FIELD SERVICE BULLETIN

FSB Number: LVCCFSB2004-259
Author: Max Dekirmandjian
Date: December 21, 2004
Total No. of Pages: 3
Subject: E398-No or Distorted Earpiece Audio
Model Affected: E398 GSM
Level of Repair: 2

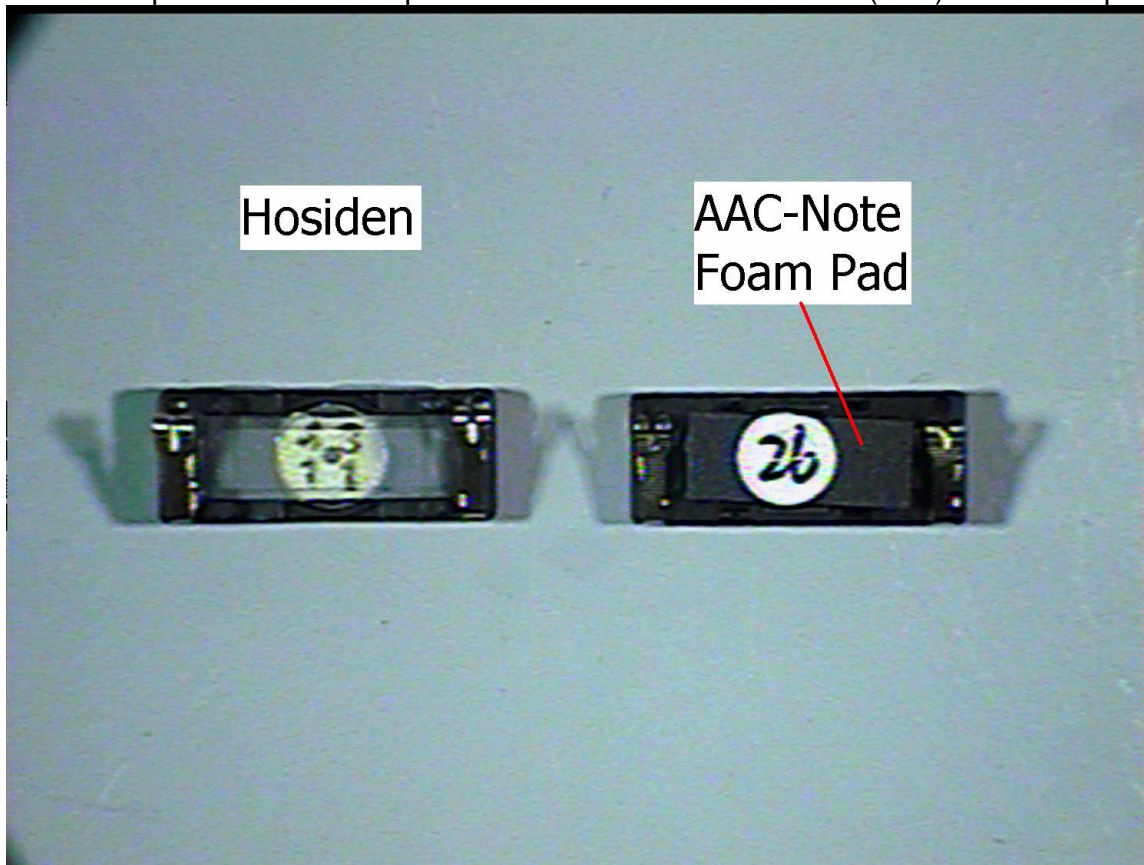
- 2) Observe the contact side of the Earpiece to determine if the manufacturer is Hosiden. The photo below shows Hosiden vs AAC Earpiece. Notice that the AAC Earpiece has a foam pad attached to the contact side (rear) of the component.

- 3) If the manufacturer is confirmed to be Hosiden, replace the Earpiece with AAC.
Note: Do not remove the foam pad from the AAC Earpiece. The foam pad remains attached to the earpiece.
- 4) Reassemble the unit and verify that earpiece audio is now functional.

Short Term: An alternate supplier, American Audio (AAC), is qualified as a 2nd source for the Earpiece. The part number is 5089574N01. AAC is to be used in E398 production starting in January 2005 and on customer returns that require Earpiece replacement.
